S E R V I C E N O T E

8657D Pi/4 DQPSK Signal Generator

Reversed Capacitor On A6 Assembly

Fig. 1: Partial view of A6 board 08657-60171 and A6C417

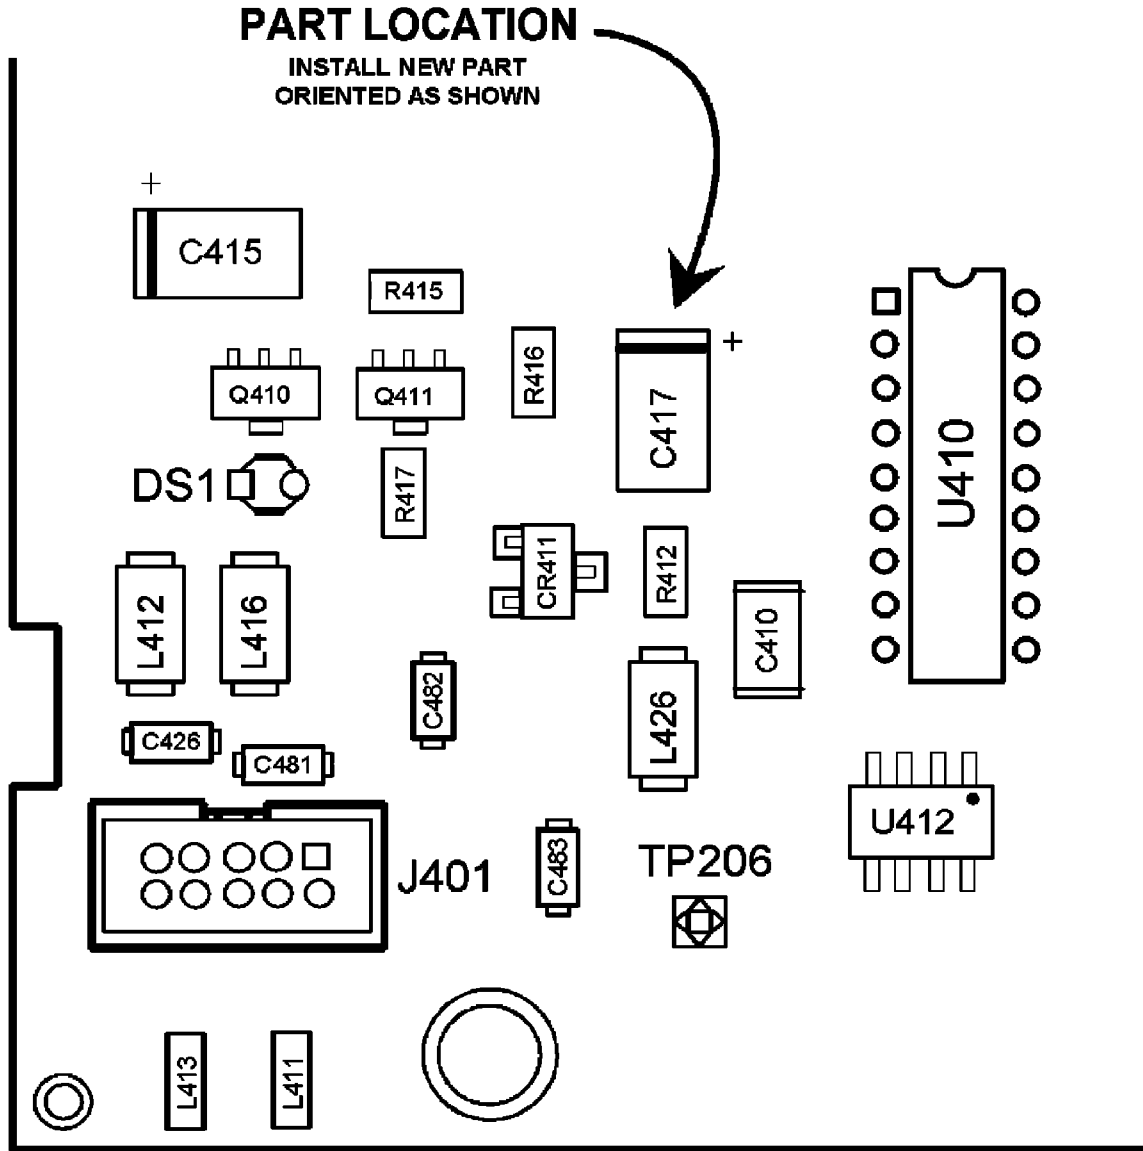
8657Ds (with serial number noted above) have capacitor A6C417 installed backwards on the A6 Output Assembly (08657-60171). The polarity marking silkscreened on the PC board is incorrect and should be ignored when installing the replacement component.

Locate and replace A6C417 with part number noted above. Refer to Figure 1 for correct location and orientation of C417. This component is an SMT (Surface Mount Technology) component which requires appropriate tools and techniques.

NOTE: DO NOT USE THE POLARITY MARKING ON THE PC BOARD TO ORIENT THE REPLACEMENT COMPONENT. DO NOT RE-USE THE ORIGINAL COMPONENT.
